Project	IEEE 802.16 Broadband Wireless Access Working Group < http://ieee802.org/16 >		
Title	Text for general MAC structures – sub-frames		
Date Submitted	2006-07-10		
Source(s)	Mariana Goldhamer Alvarion 21, HaBarzel Street Tel Aviv, Israel	Voice: Fax: mailto:	+972 544 22 55 48 +972 3 6456241 mariana.goldhamer@alvarion.com
Re:	IEEE 802.16h-06/015 – Working Group Review		
Abstract	Introduces the Master / Slave MAC sub-frames		
Purpose			
Notice	This document has been prepared to assist IEEE 802.16. It is offered as a basis for discussion and is not binding on the contributing individual(s) or organization(s). The material in this document is subject to change in form and content after further study. The contributor(s) reserve(s) the right to add, amend or withdraw material contained herein.		
Release	The contributor grants a free, irrevocable license to the IEEE to incorporate material contained in this contribution, and any modifications thereof, in the creation of an IEEE Standards publication; to copyright in the IEEE's name any IEEE Standards publication even though it may include portions of this contribution; and at the IEEE's sole discretion to permit others to reproduce in

Figure h14—Interference due to overlapping networks

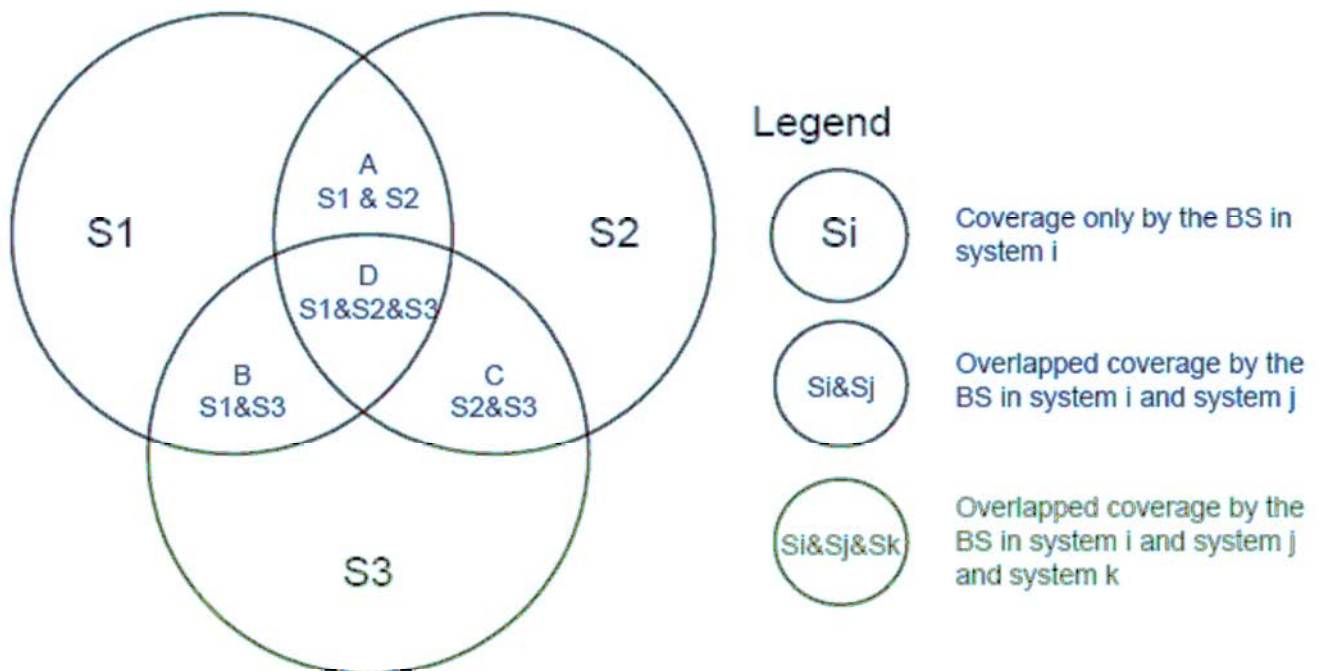
The assignment of different MAC sub-frames as Master/Slave sub-frames is based on the observation that in real deployment (see fig. h14) not all the data transmission connections create or are affected by interference. The overlapping radio systems create different interference zones based on the spatial distance between transmitters and receivers. As example of BS to SS interference, the radio receivers located in Zone A are affected by interference between system 1 and system 2.

The operation of the three systems in Figure h 14 assume the following different situations:

- Zones in which the systems 1, 2 and 3 do not interfere and the traffic can take place in parallel, using the same common sub-frame;
- Zone A: systems 1 and 2 interfere;
- Zone B: systems 1 and 3 interfere;
- Zone C: systems 3 and 2 interfere;
- Zone D: systems 1 and 2 and 3 interfere.

Figure h17—Examples of WirelessMAN-CX sub-frames

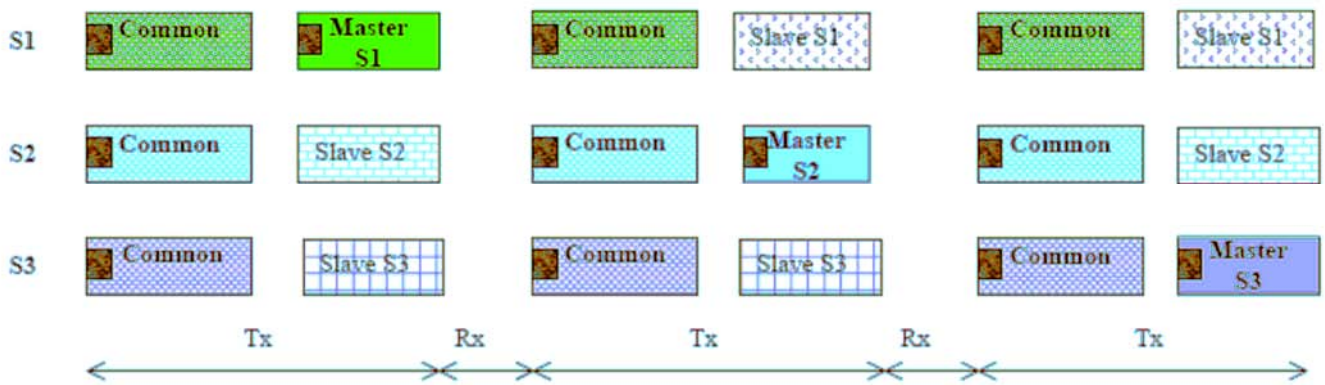
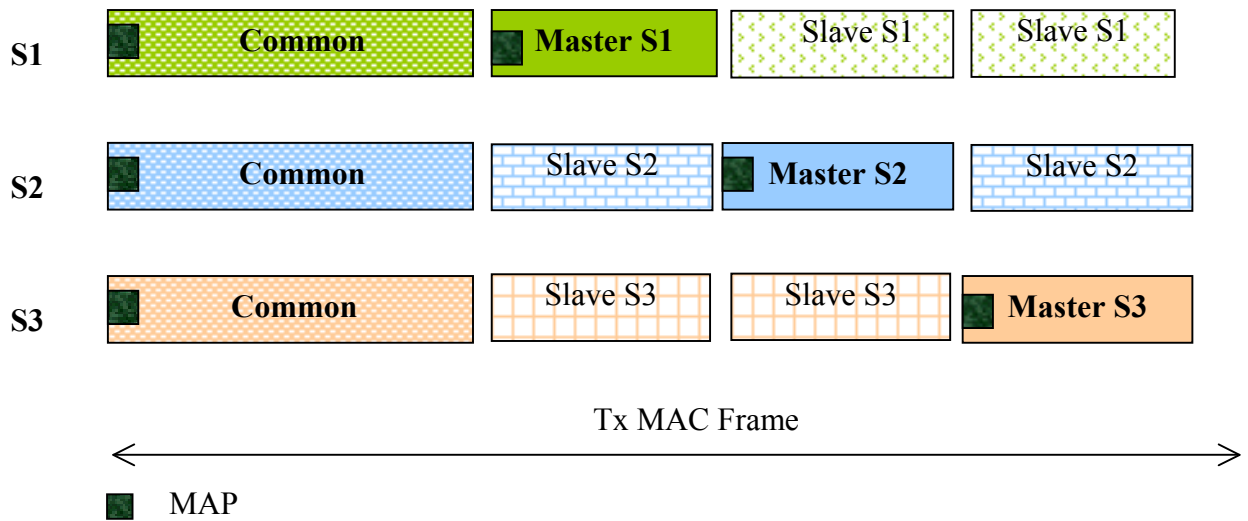
In order to avoid the interference, the traffic in the interfering areas A, B, C and D shall be scheduled in such a way that the interfering connections will not operate in the same time. A sub-frame called Master sub-frame is allocated to each system (see fig. h17), such that the interfering systems have Master sub-frames which do not overlap.

The system specific Master sub-frames can be scheduled during same MAC Frame (fig. h17-upper part) or in consecutive MAC Frame (fig. h17 - lower part). They should start with a private MAP, scheduling the traffic for the users that are affected by harmful interference, like those in the overlapping areas S_i & S_j in fig. h14. The isolation of interference is achieved by the allocation of different transmission/reception times for the traffic in the overlapping areas, such that each system will have its own interference-free "Master" sub-frame.

The examples in fig. h17 show three systems having the Master sub-frames scheduled in one long MAC Frame or in three consecutive short MAC Frames.
